Coastal Access Modification Report MR1

Proposed changes to the submitted England Coast Path proposals for Portsmouth to South Hayling

Locations affected: Eastney Peninsula and Kendalls Wharf

Natural England's Modification Report to the Secretary of State

Table A.3.1 Details for sections that differ from the original proposed route - Map MR1A: Eastney Peninsula

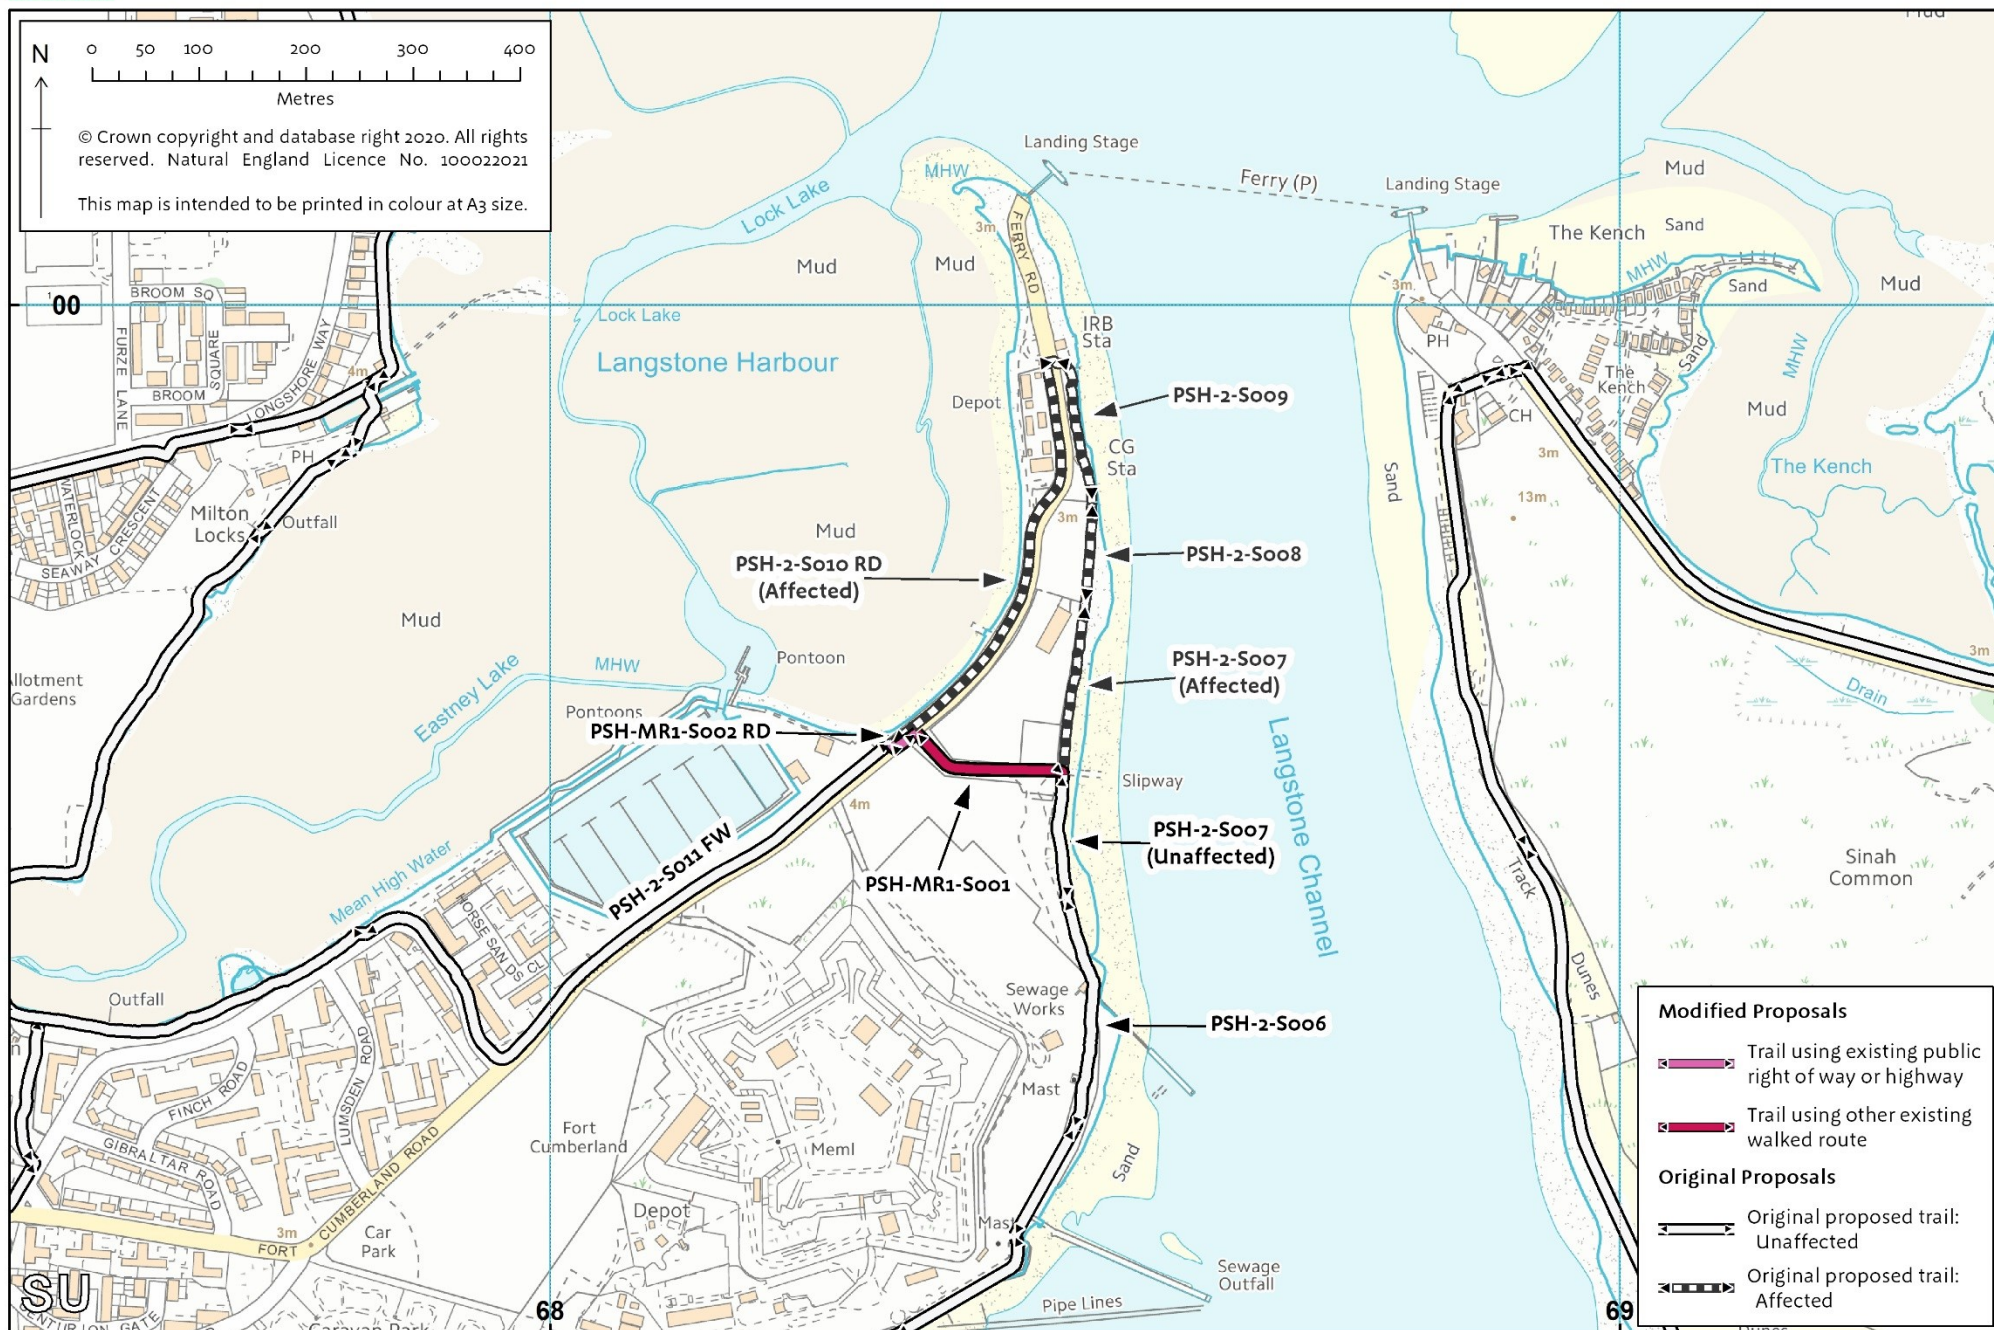
A.1.1 Our original alignment of the ECP in this area, as proposed in Natural England's original [report](#), followed the shingle beach up the peninsula towards the Life Boat Station and then onto Ferry Road and Fort Cumberland Road to continue around the harbour.

A.1.2 Subsequent to publishing our original report, a section of the shingle beach was washed away by a storm, and as a result the path became impassable and unsatisfactory to walk on.

A.2.1 Our proposal is to shorten the proposed route around Eastney Peninsula. The modified route is approximately 160m in length and follows an existing access road between Ferry Road and the (public) slipway by the Southsea Anglers Club. The modified route is labelled PSH-MR1-S001 and PSH-MR1-S002 on Map MR1A and connects between original route sections PSH-2-S007 to PSH-2-S010.

A.2.3 The proposed trail consists of a tarmac road, therefore it is more suitable for some people with reduced mobility than parts of the original route. The original path was aligned on the shingle beach up the eastern side of the peninsula before following a tarmac road back down the western side of the peninsula. We have chosen this route alignment as it provides the next best route to ensure the continuity of the trail, whilst meeting the principles of the Coastal Access Scheme, namely closeness to
